# Access Compliance Report

## Public Rights-of-Way

Intersection ID: 46308	Main Street: DONNEGAL_FARM_RD	Cross Street: BECKET RIDGE_RD	Location: NW
ADA ID: 4F1DBE402749	Ramp Type: PerpDiag	Initial Pass/Fail: Fail	Overall Compliance: No
Severity Score: 10			
Codes/Mitigation Info/Possible Solution		Field Measurements/Component Compliance

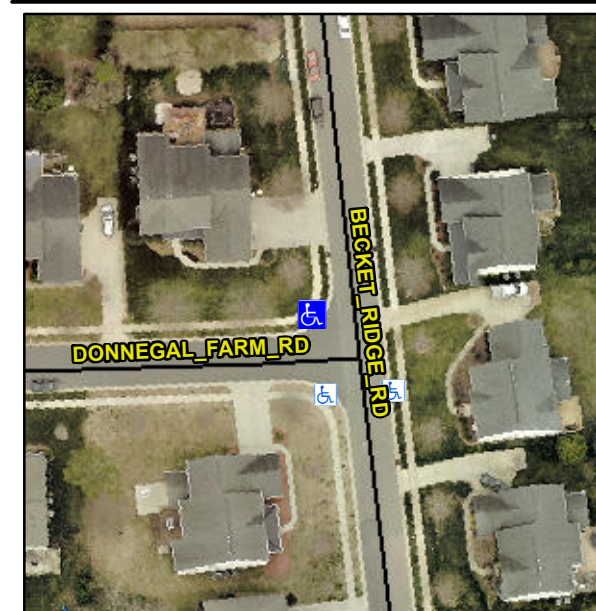
**Not Found, R304.5.1, R304.5.3**

Compliance	Description	Data	Compliance	Description	Data
N/A	Ramp Length (in)	51.0	Yes	Ramp Slope (%)	8.0
No	Ramp Width (in)	40.5	No	Ramp XSlope (%)	4.5
N/A	Flare Type LT	N/A	N/A	Flare Type RT	N/A
N/A	Flare Slope LT (%)	N/A	N/A	Flare Slope RT (%)	N/A
N/A	Flare Traversable LT?	N/A	N/A	Flare Traversable RT?	N/A
N/A	Landing Length (in)	N/A	N/A	DWS Provided?	N/A
N/A	Landing Width (in)	N/A	N/A	DWS Contrast?	N/A
N/A	Landing Slope (%)	N/A	N/A	DWS Length (in)	N/A
N/A	Landing X Slope (%)	N/A	N/A	DWS Full Width?	N/A
N/A	Landing Curb? (Y/N)	N/A	N/A	DWS Offset (in)	N/A
N/A	Shared Landing?	N/A			
N/A	Gutter Ponding?	N/A	N/A	Gutter Slope (%)	N/A
N/A	Gutter Lip Ht (in)	N/A	N/A	Gutter X Slope (%)	N/A
N/A	Painted X Walk1?	No	N/A	Painted X Walk2?	No
	X Walk 1 Direction	To S		X Walk 2 Direction	To E
N/A	X Walk 1 Width (in)	N/A	N/A	X Walk 2 Width (in)	N/A
	X Walk 1 Slope (%)	3.0		X Walk 2 Slope (%)	1.5
	X Walk 1 X Slope (%)	3.2		X Walk 2 X Slope (%)	2.0

**Remove & Replace Curb Ramp With Two New Directional Ramps or Equivalent.**
